Architectural Review Board Regular Meeting Agenda: April 1, 2021

3. Public Hearing: Recommendation on Objective Design Standards (Continued from March 18th, no staff report changes, Attachments B-E added)

Report Type:	Action Items	Meeting Date: 4/1/2021
Summary Title:	ARB Recommendation on Objective Design Standards	
Title:	Public Hearing: Recommendation on Objective Design Standards (Continued from March 18th, no staff report changes, Attachments B-E added)	
From:	Jonathan Lait

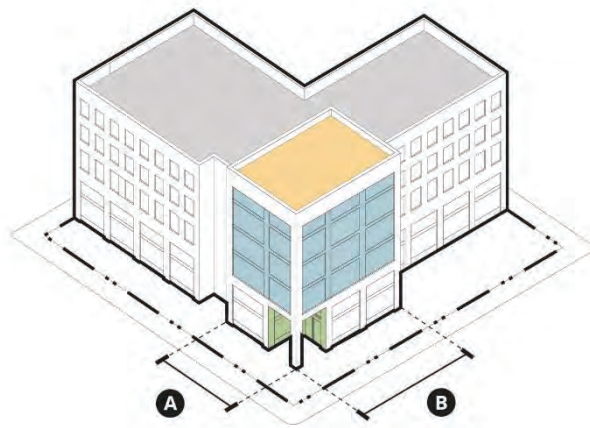
IS THERE A SECTION FOR MID-BLOCK BUILDINGS, WITH NEIGHBORS ON ON 2 SIDES? 1

-
- ☰ Number: 1 Author: elaine Subject: Text Box Date: 12/5/2020 2:11:08 PM
IS THERE A SECTION FOR MID-BLOCK BUILDINGS, WITH NEIGHBORS ON ON 2 SIDES?
-
- 📄 Number: 2 Author: elaine Subject: Highlight Date: 12/5/2020 1:52:08 PM
60 feet
-
- ☰ Number: 3 Author: elaine Subject: Text Box Date: 1/18/2021 8:53:29 AM
WHY 60'? THE HISTORIC BUILDING AT RAMONA AND UNIVERSITY AVE - ONE OF PALO ALTO'S MOST ICONIC BUILDINGS - PROBABLY WOULD NOT MEET THIS STANDARD
-
- ☰ Number: 4 Author: elaine Subject: Text Box Date: 12/5/2020 2:23:55 PM
CORNER TREATMENTS MAY HAVE DIFFERENT CONSIDERATIONS ALONG ECR OR SAN ANTONIO VS UNIVERSITY AVE. EVEN A CORNER BLDG ON A SMALLER STREET LIKE LYTTON AVE OR COLLEGE AVE MAY NEED DIFFERENT STANDARDS

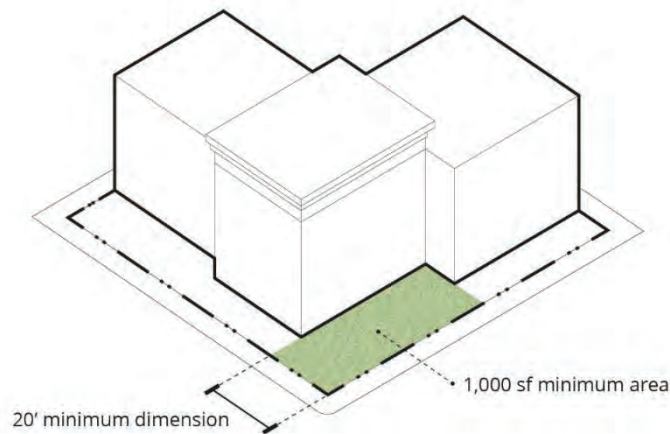
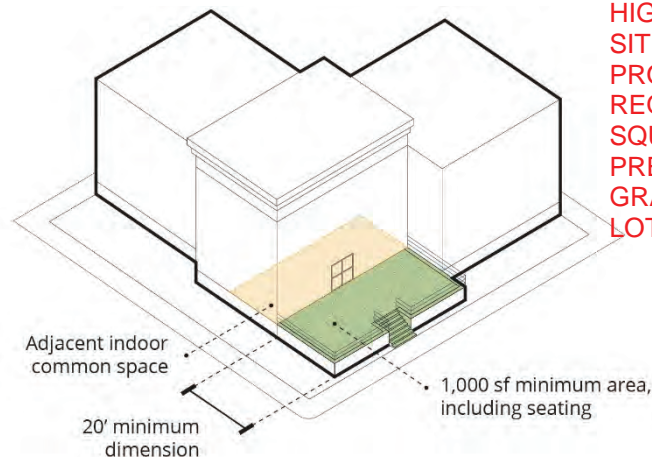
² NARROW DEPTH SITES MAY NEED AN EXEMPTION. A LOT OF GOOD PUBLIC ACTIVITY CAN HAPPEN IN A 12-15' DEPTH. 1000SF OVERALL SEEMS HIGH (20'X50'!), ESPECIALLY ON SMALLER SITES. RECOMMEND 500 SF MIN OR A GRADUATED MINIMUM BASED ON MINIMUM LOT SIZE (IE 500 SF FOR SITES < 1/4 ACRE, 750 FOR SITES < 1/2 ACRE AND 1000 SF FOR SITES OVER 1/2 ACRE.

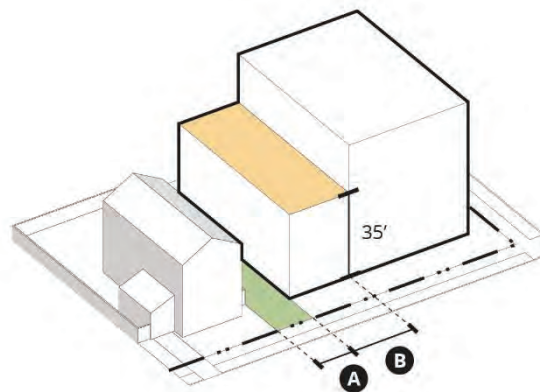
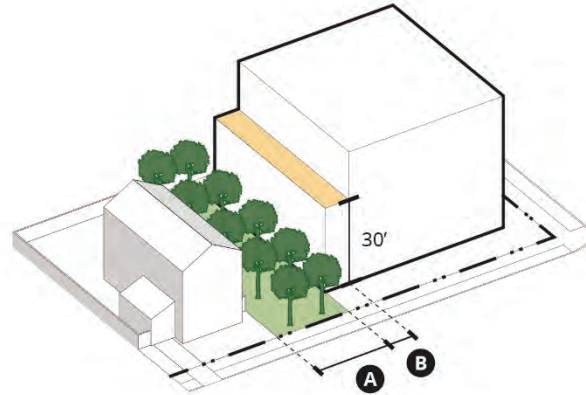
RIGHT SIDE DIAGRAM OF THIS BLDG IS THE TALLEST ALLOWABLE IN PALO ALTO RIGHT NOW! YOU MAY WANT TO EDIT TO SHOW RELATIONSHIP BETWEEN 2 STORY AND 4 STORY STRUCTURE

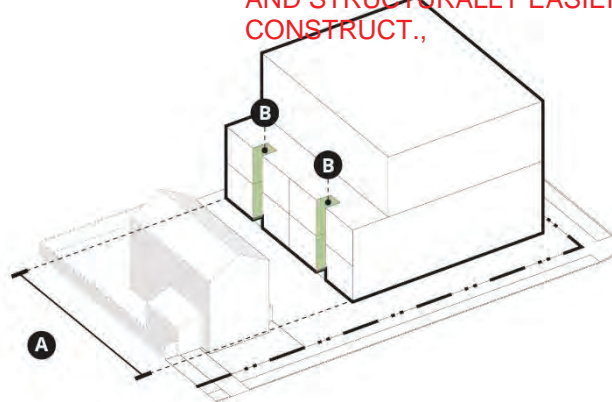
6' DEPTH IS A LOT ESPECIALLY ON SMALLER SITES, <100' IN ONE DIRECTION. 2-3' IS BETTER AND STRUCTURALLY EASIER/CHEAPER TO CONSTRUCT.,

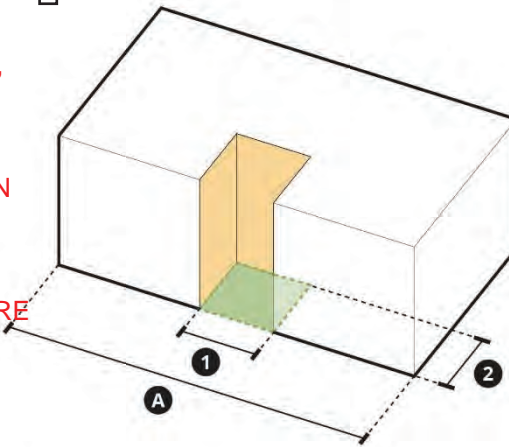
100' LONG SITES ARE NOT THAT LONG/WIDE, INSTEAD OF MANDATING THIS HUGE BREAK, USE MASSING TO CONTROL VARIATION ALONG A FACADE, ALTERNATIVE: CHANGE 100' TO BLDGS OVER 200' IN LENGTH

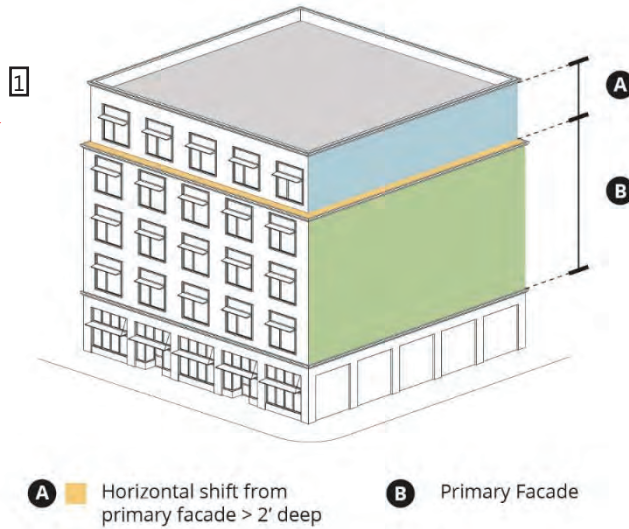
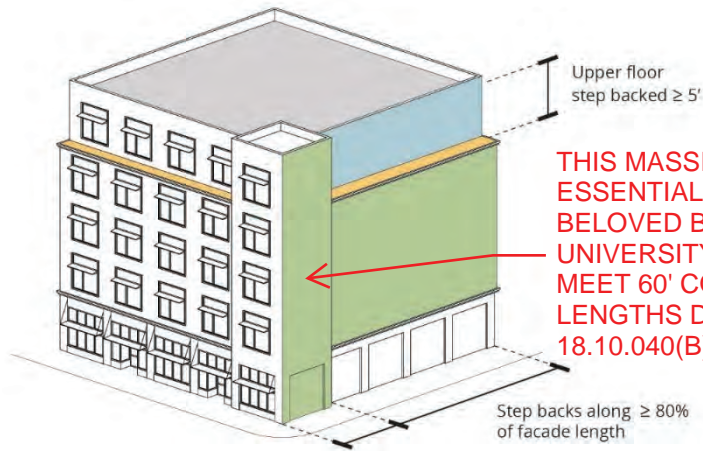
LOVE THESE DIAGRAMS, BUT THEY ILLUSTRATE BUILDINGS TALLER THAN PALO ALTO'S CURRENT 50' HEIGHT LIMIT (WE SHOULD ALLOW STRUCTURES THIS TALL THOUGH!)

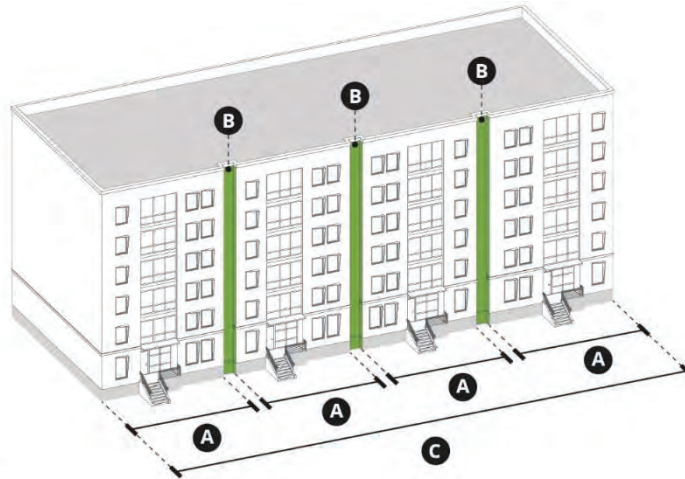
THIS MASSING IS GOOD, ESSENTIALLY A DIAGRAM OF THE BELOVED BUILDING AT RAMONA & UNIVERSITY, BUT IT MIGHT NOT MEET 60' COMBINED CORNER LENGTHS DESCRIBED IN 18.10.040(B)i(a)1

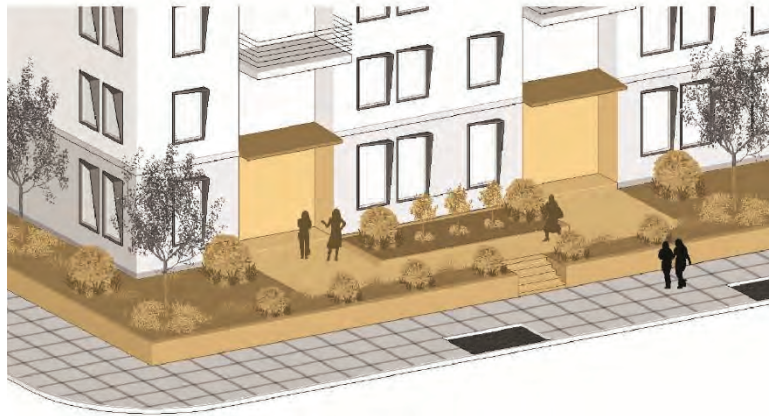
BE CONSISTENT WITH 18.10.024.(C)ii WHICH SAYS 36 SF AND MIN 5' DIMENSION
